Service Bulletin

W422

SUBJECT: 240v/50 Hz Williston Built Venders Serial Plate
Refrigerant Specification

MODELS AFFECTED: All Williston built 240v/50 Hz export venders built
prior to production run 6024 (July 1, 1991).

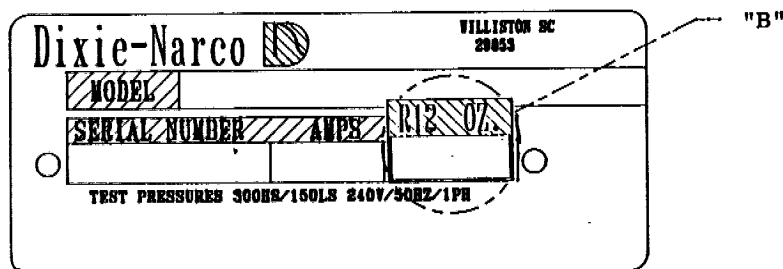
REASON: To enable customers to identify subject venders with serial
plates incorrectly listing R500 as refrigerant used to charge
system and correct this by placing an R12 OZ. label to show
correct refrigerant used to charge system.

1. On subject venders locate both serial plates:
 - a. Serial plate on left side of main door.
 - b. Serial plate on refrigeration base plate.
2. Locate the refrigerant specification on the serial plates;
See "A" below.

3. Place new R12 OZ. label supplied 
over R500 refrigerant specification on each serial plate.
See "B" below.

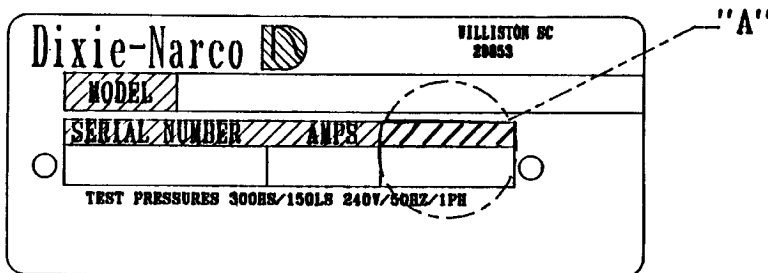
EXCEPTION: 90 DNCB 276 Diet Coke Tamworth Staff venders on production run 6024 (July 1, 1991).

REASON: To provide an R12 OZ. label for serial plate to show refrigerant used to charge system.

1. On subject venders locate both serial plates:
 - a. Serial plate on left side of main door.
 - b. Serial plate on refrigeration base plate.
2. Locate the area on serial plate that would typically have refrigerant specification. See "A" below.

3. Place new R12 OZ. label supplied

over refrigerant specification area on each serial plate. See "B" below.
